**APPLICATION FOR VARIANCE
TO COMAR ONSITE WATER/SEWER FOR MDE APPROVAL**

2730 Jennings Chapel Road;

Savage Property (proposed)

ALTERNATIVE COMPLIANCE APPLICATION

P 46743

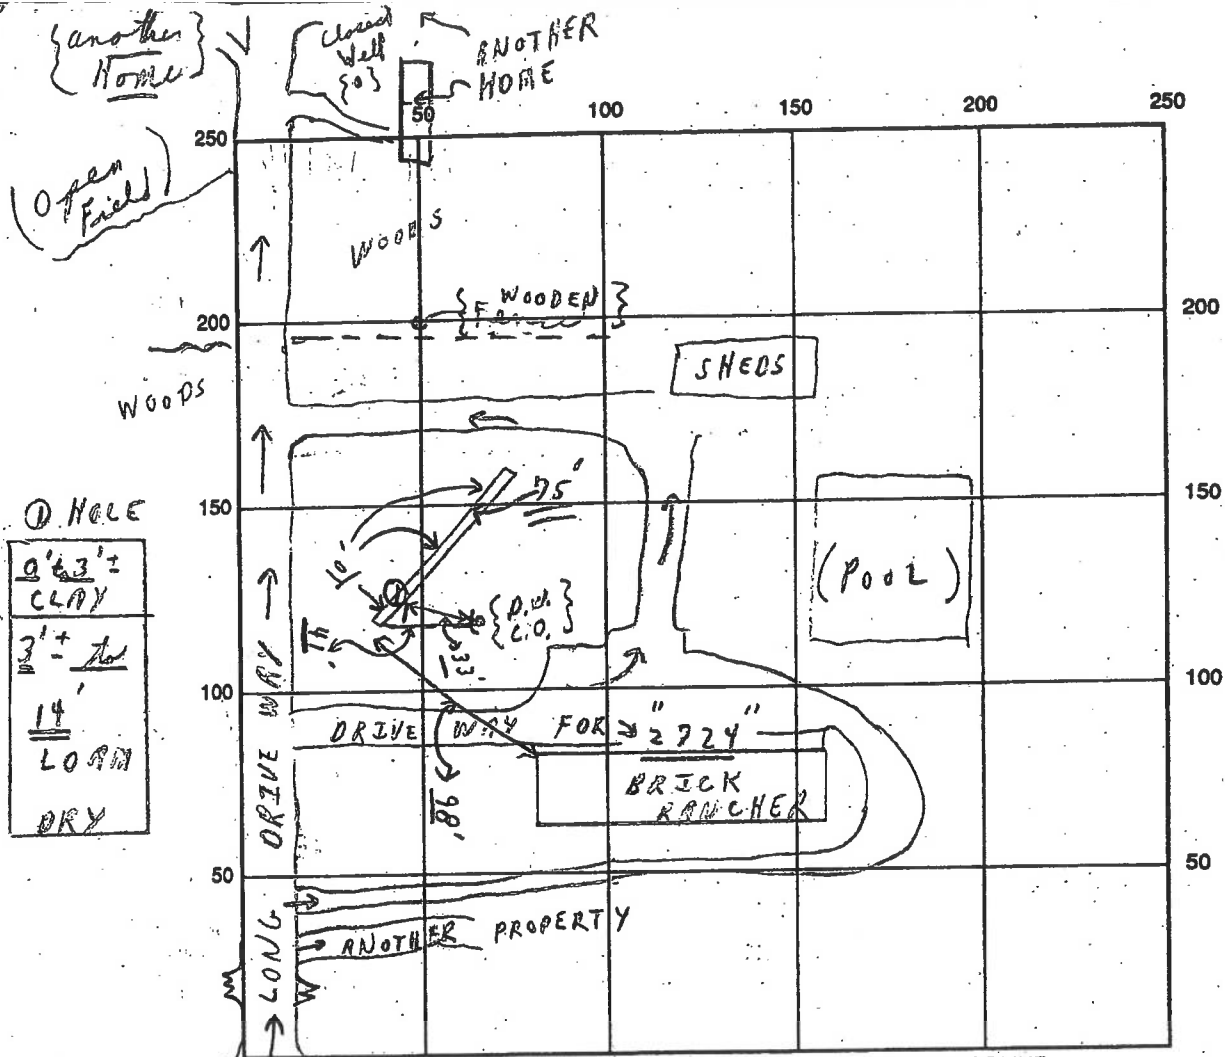
REMARKS: A.M. 1/4/91 Located 1 hole, visual - observed; 1 trench
to come off existing dry well. OK
P.M. - Trench - ok to finish & cover as complete;
(2/3 complete + material on site)
